PROPERTY DETAILS: 873 Wallaces Gap Road BALLALABA NSW 2622
Lot 81 DP 755905

FILE NO'S: DA.2026.0113

SUBJECT: Referral to Development Engineer for Comments

DESCRIPTION: Construction of a solar farm, battery energy storage systems, landscaping and associated site works

Figure 1: Wallaces Gap Road – Speed Zone

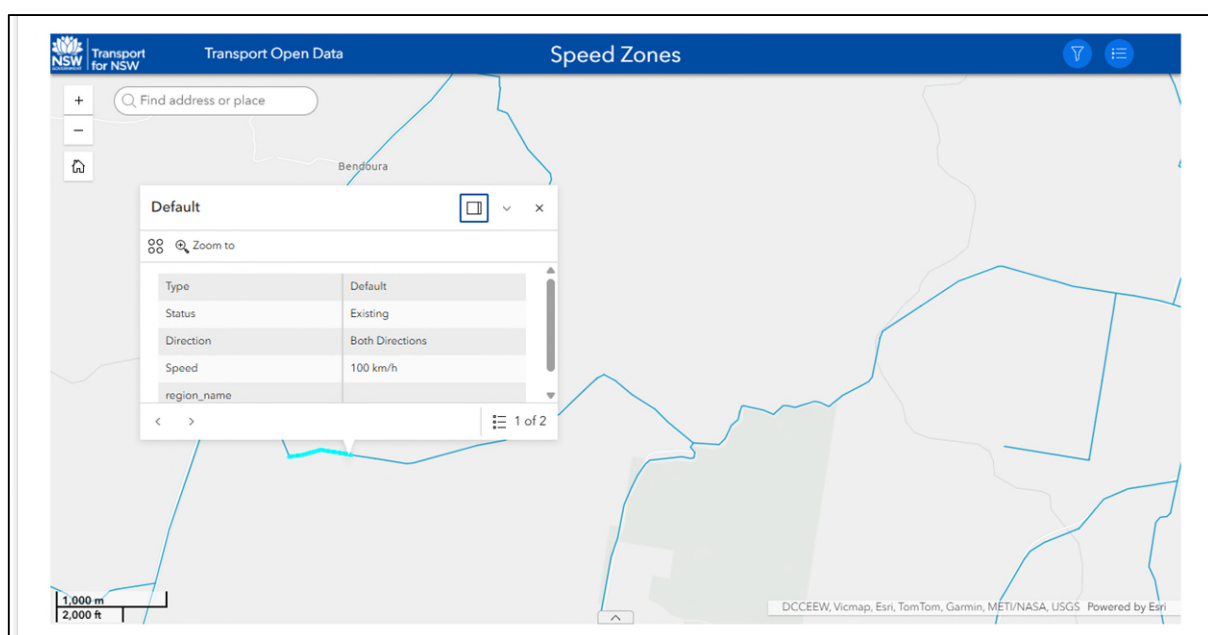
The proposed site at 873 Wallaces Gap Road, Ballalaba, will be accessed via the existing access off Wallaces Gap Road. All construction and delivery vehicles will need to travel approximately 2.8km along Wallaces Gap Road to reach the site. Wallaces Gap Road is an un-signposted rural road with a default speed of 100km/h in accordance with TfNSW Speed Zones data. While 100km/h appears to be an upper limit due to unfavourable road conditions, locals are expected to travel at speeds above 80km/h on large sections of the road.

Figure 2: Intersection Cooma Road and Wallaces Gap Road – Approximate Available Sight Distance

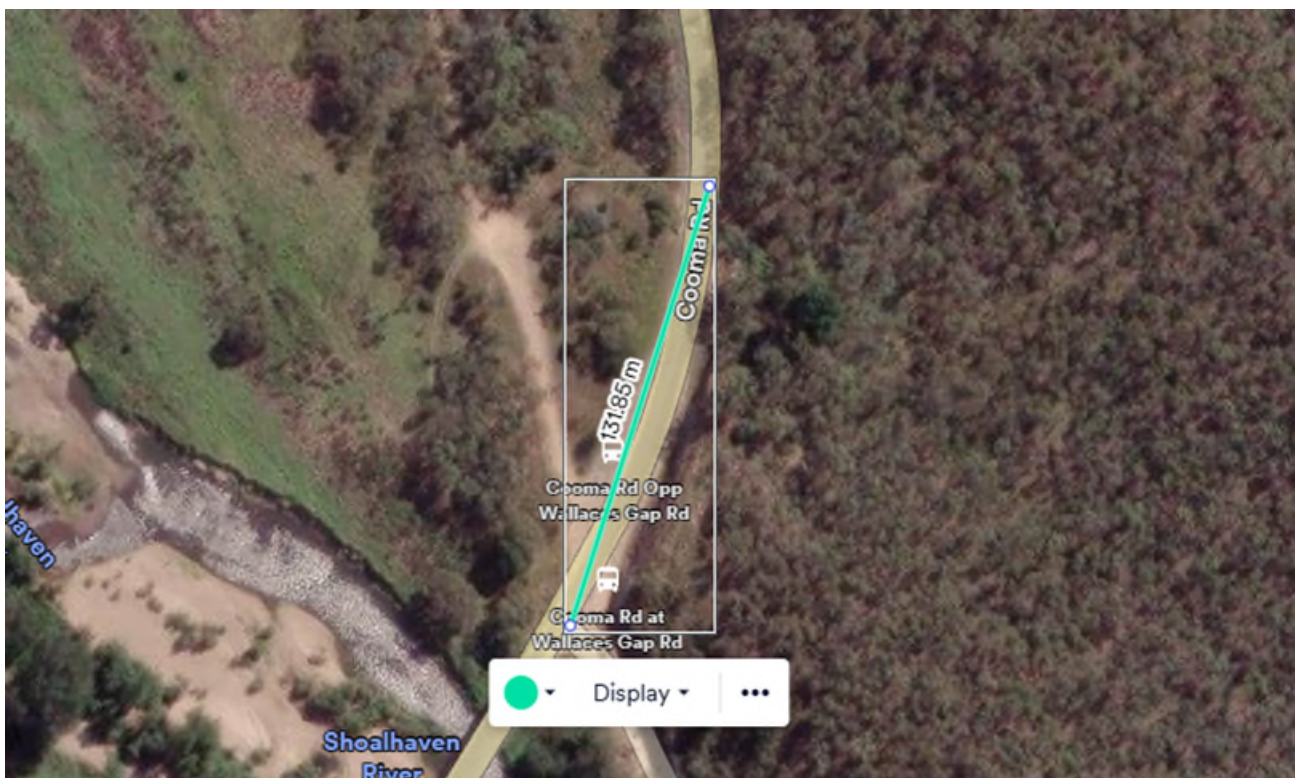
The submitted traffic impact statement has not considered the sight distance available at Wallaces Gap Road and Old Cooma Road.

The proposal would require **eight (8) articulated vehicle trips per day** and 80 construction vehicle trips per day during construction. This is a significant increase in the number of vehicles that will need to utilise the existing road network, including the intersection. **Due to the existing topography of Cooma Road**, the available sight distance to the right exiting Walaces Gap Road is less than **130m**. This is a considerably shorter sight distance than the required Safe Intersection Sight Distance (SISD) of 296m. The current available sight distance would not be sufficient for the conservative required Stopping Sight Distance (SSD) of 225m as outlined in the Austroads Guide to Road Design Part 4A. **As such, development engineering does not support the use of Wallaces Gap and Old Cooma Road intersection for additional vehicles, including articulated vehicles.**

Figure 4: Heavy Vehicle Load Distribution

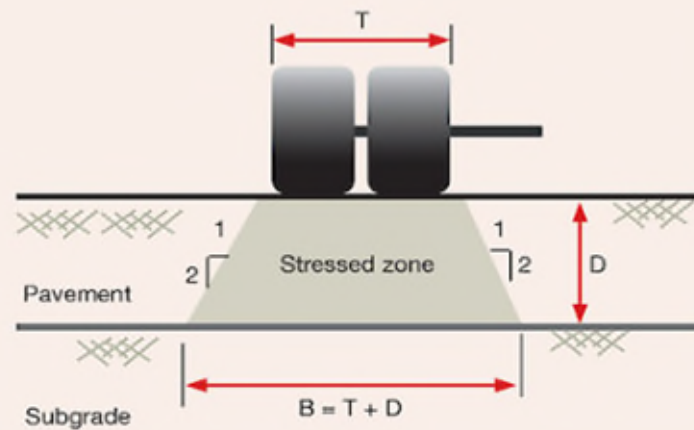
Development engineering also noted during the site visit that sections of road adjacent to the Shoalhaven River have a high erosion risk. The pavement formation on the subject section is narrower, with no shoulder lane to spread the load of heavy vehicles, increasing the risk of road collapse. A detailed slope stability analysis will need to be carried out and included as part of development applications.
